November 17, 2025
Subject: Pleasant Avenue Crossing
Bridge Wearing Surface
Replacement
State WIN: 023120.00
Location: **Dover Foxcroft**
Amendment No. 4

Please make the following changes to the Bid Documents:

DOVER BRIDGE
PISCATAQUIS RIVER
DOVER-FOXCROFT PISCATAQUIS COUNTY
LIGHTING DETAILS (1 OF 2)

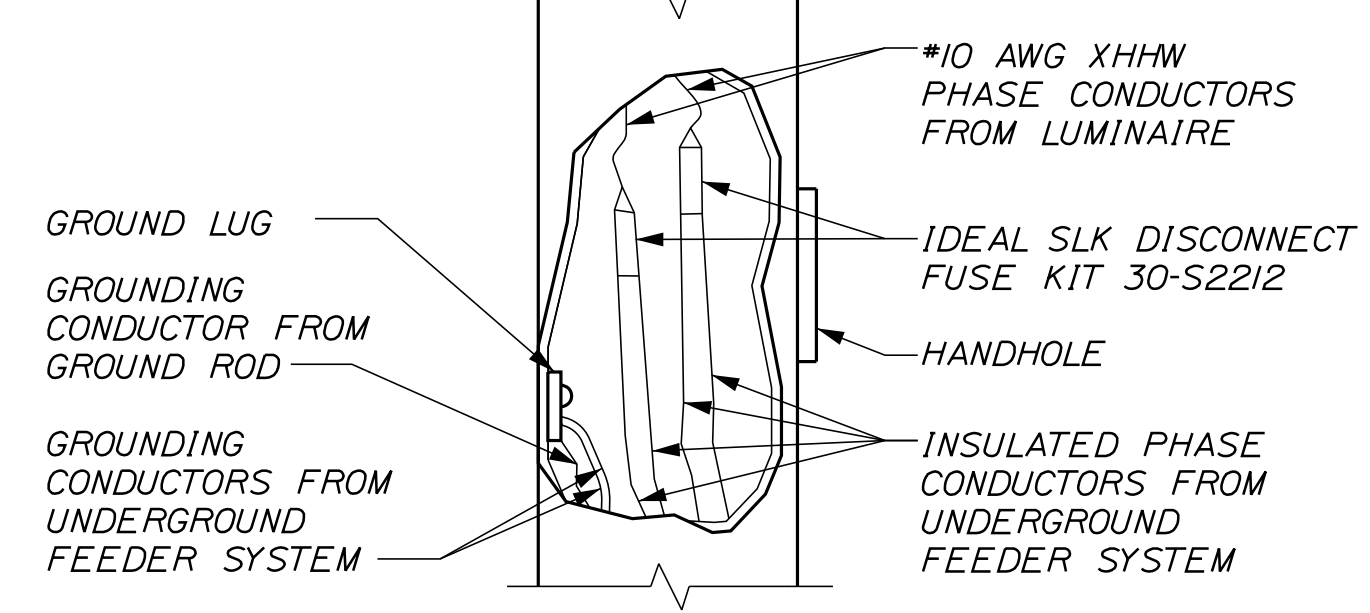
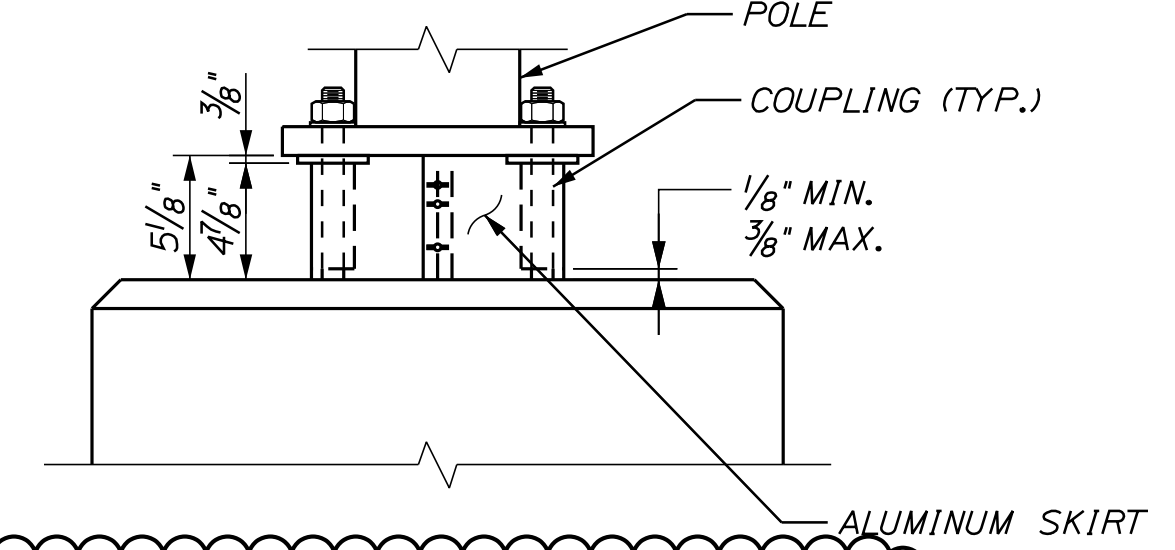
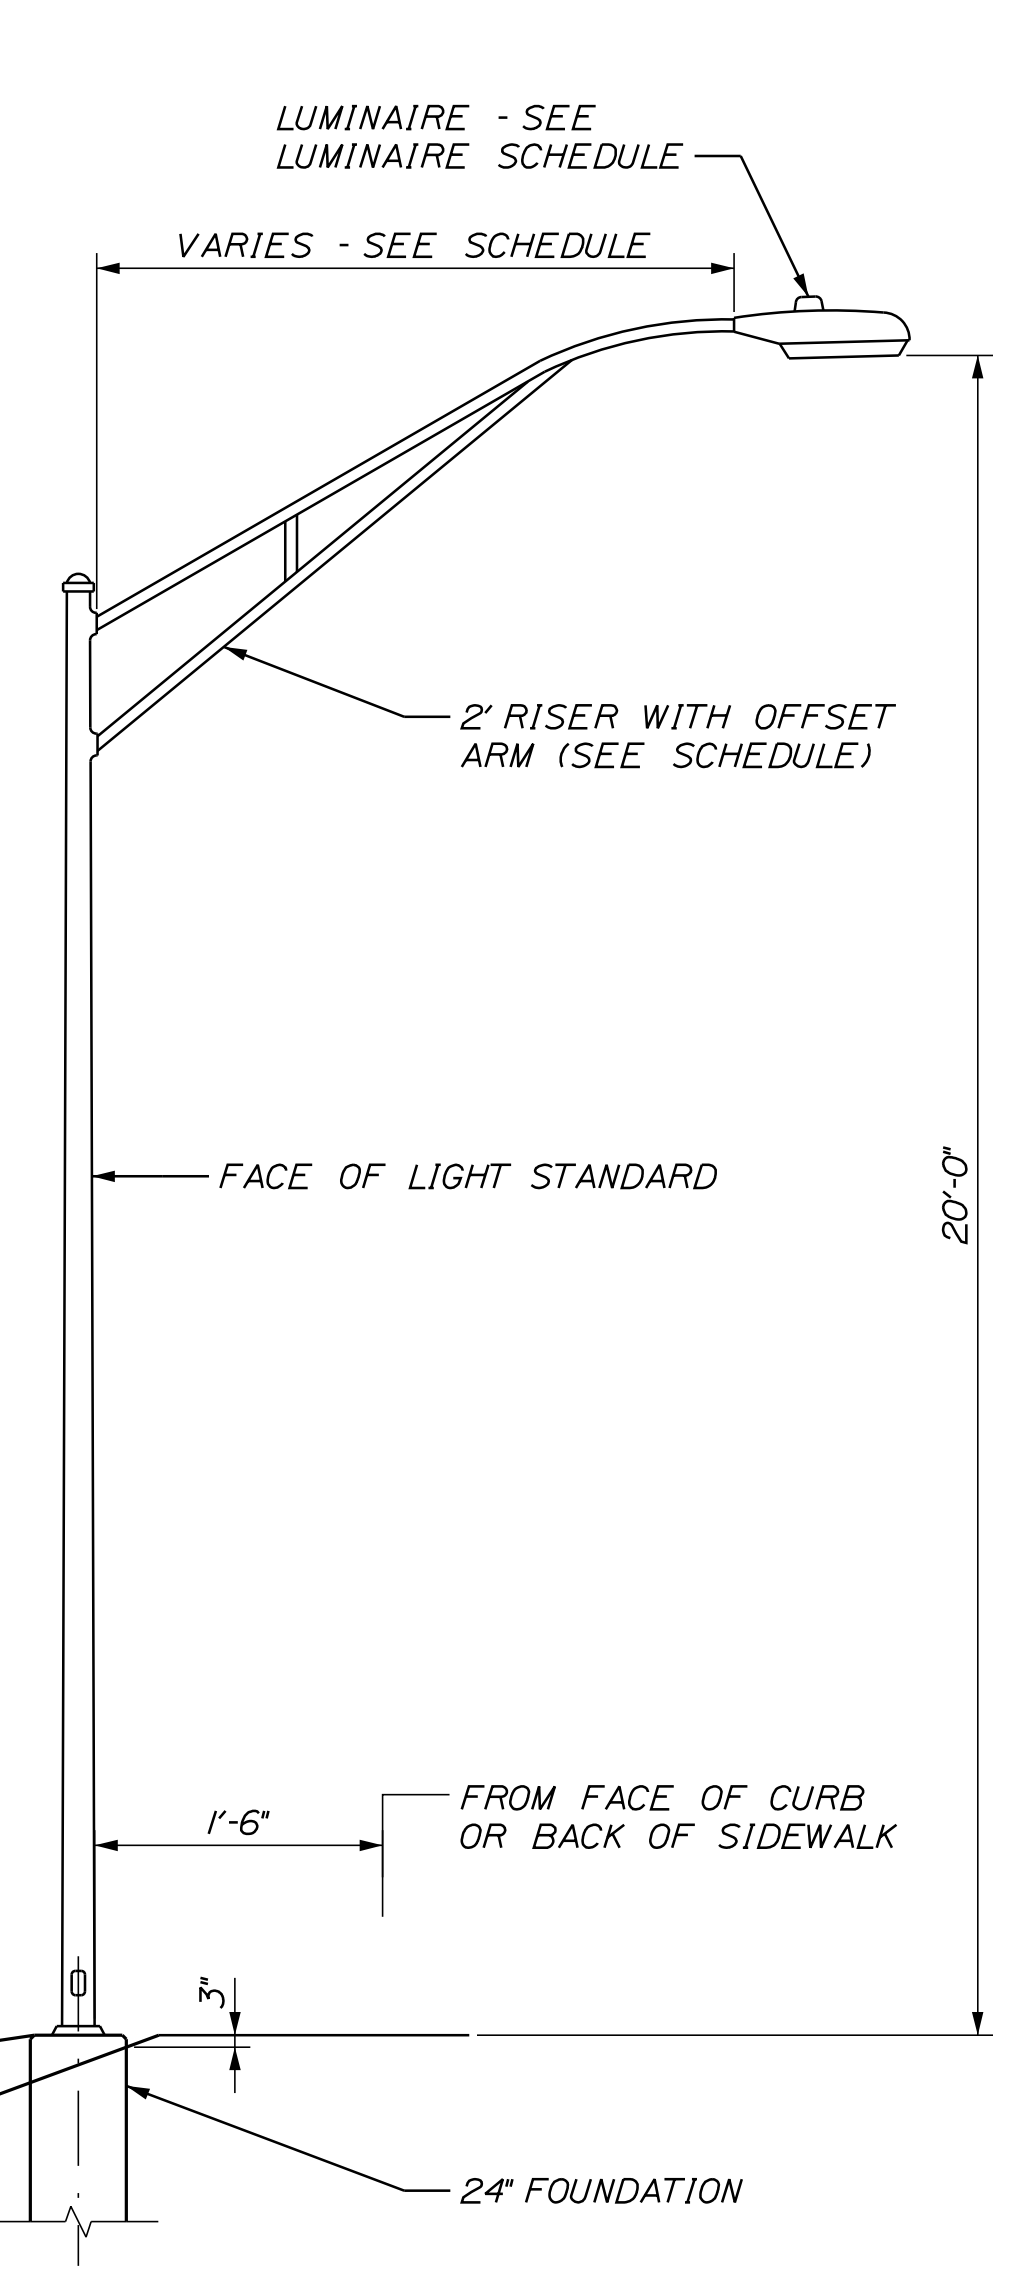
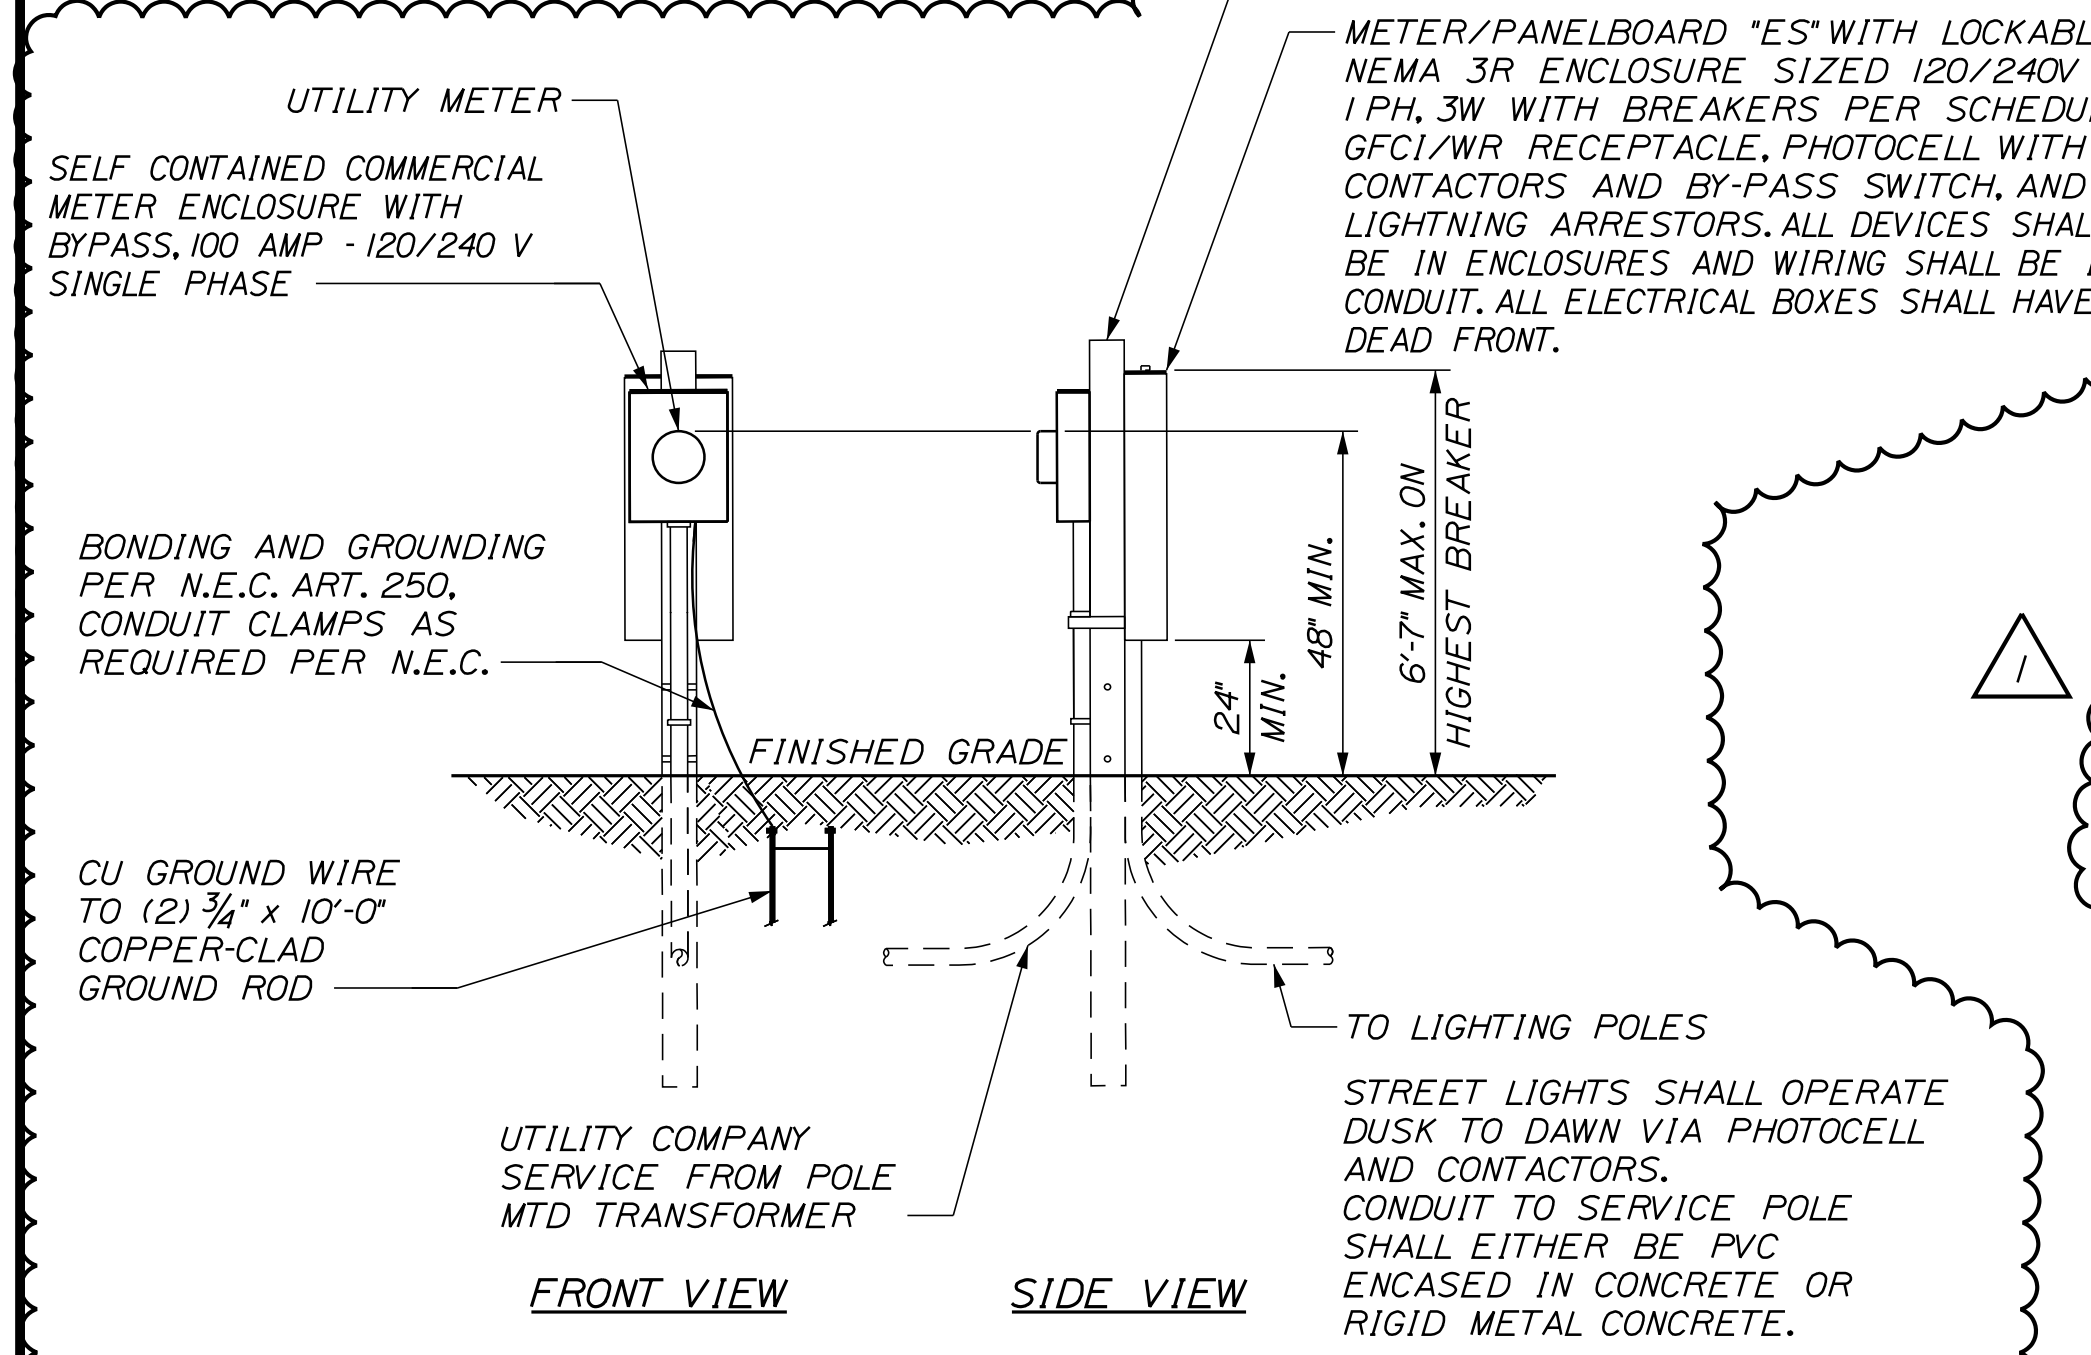
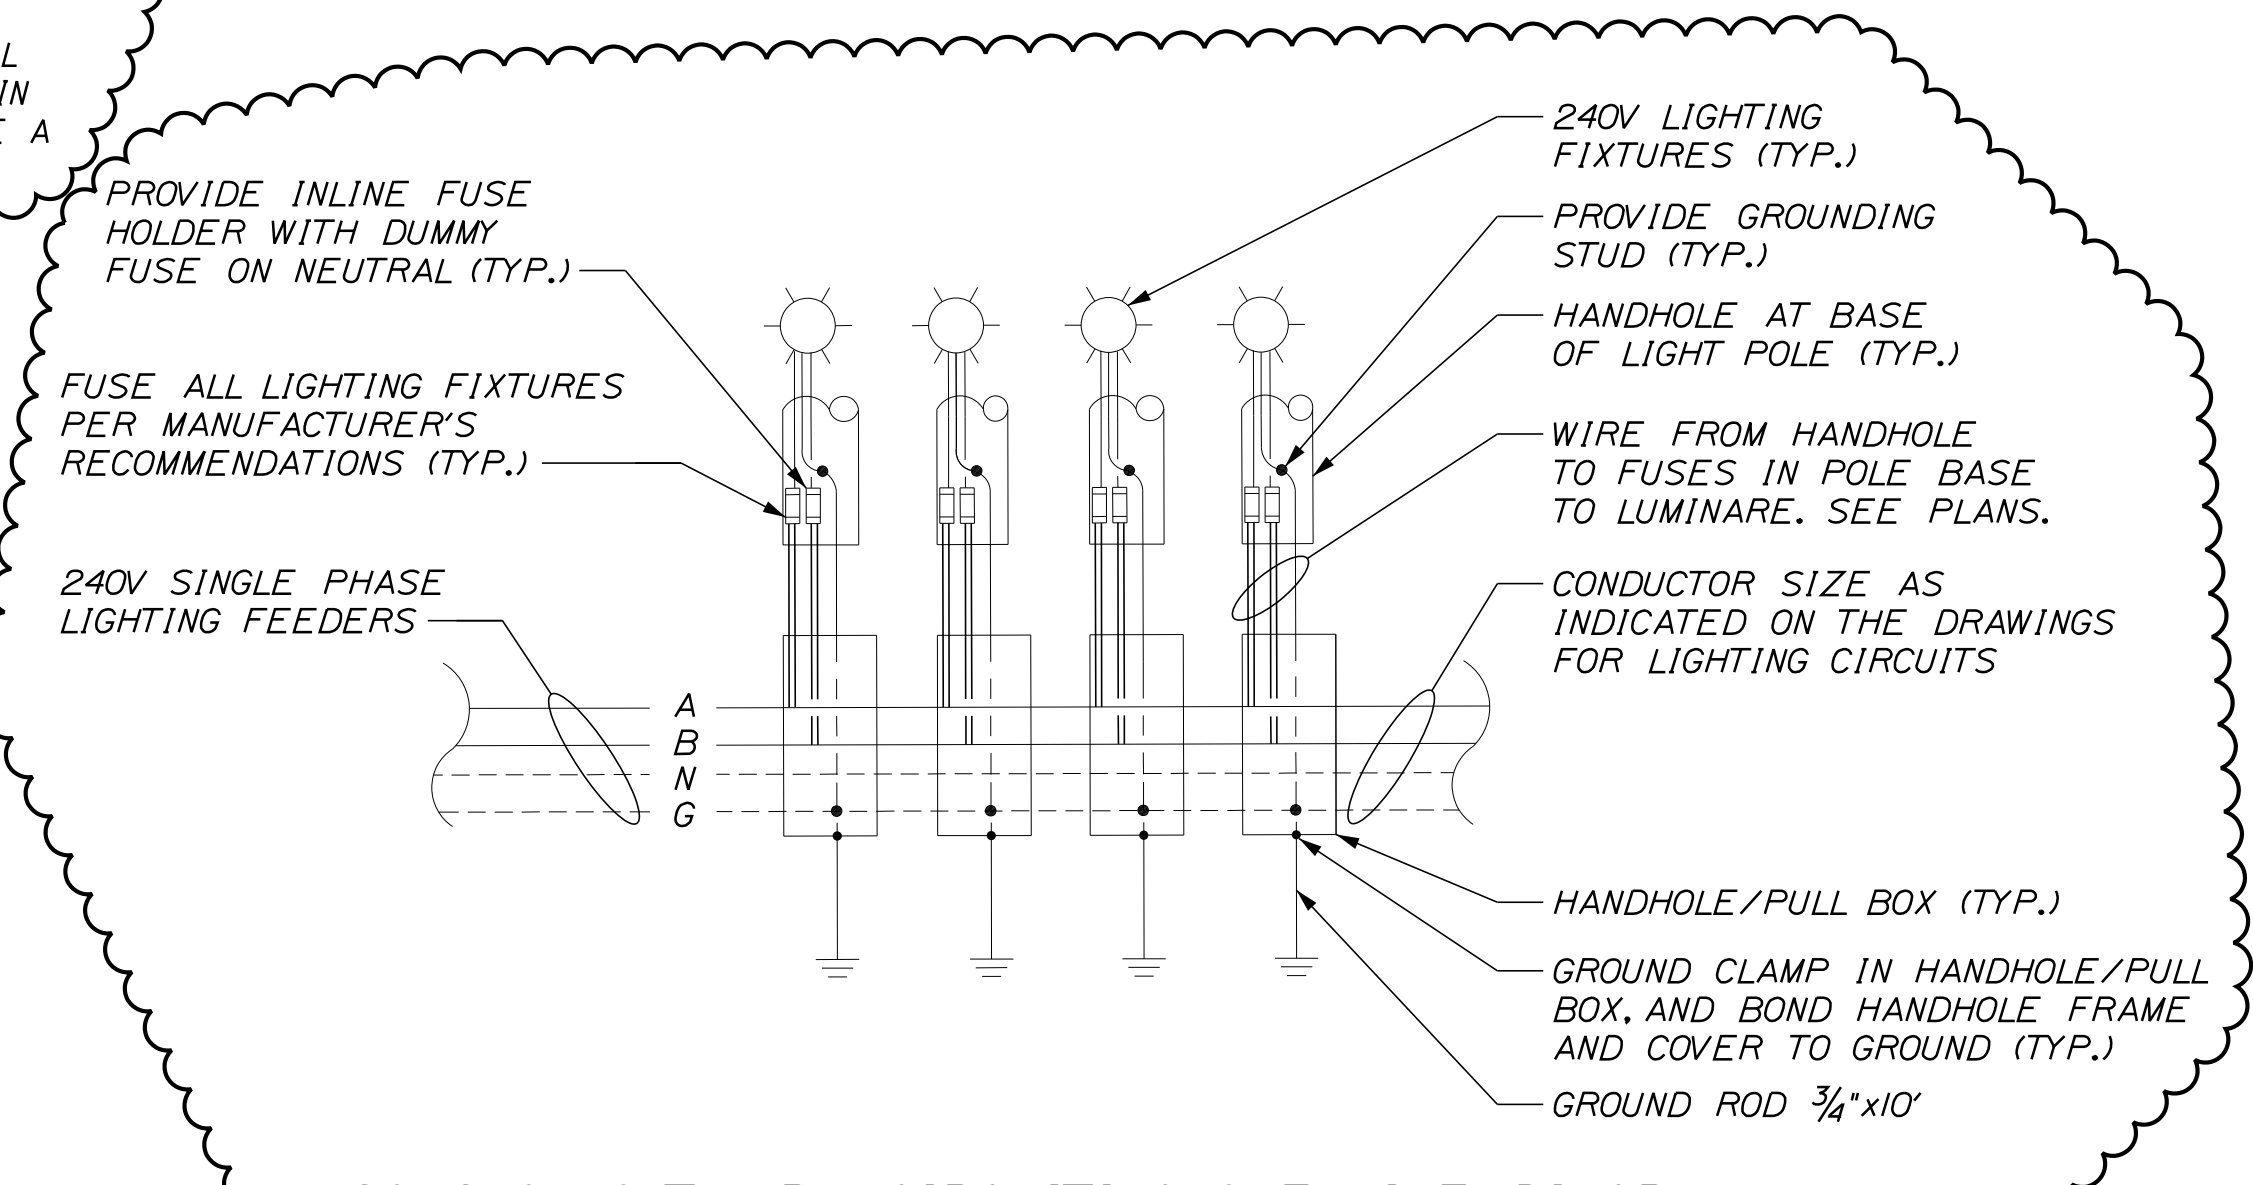
Question: Sheet 58 “Street Lighting Schedule” indicates the poles U1, U2, & U3 are mounted on have a Bolt Cover base type. Is this an error? It appears the 3 relocated wood utility poles are installed by the Utility Company.

Response: U1, U2, and U3 are provided and installed by the utility company, bolt covers are not required.
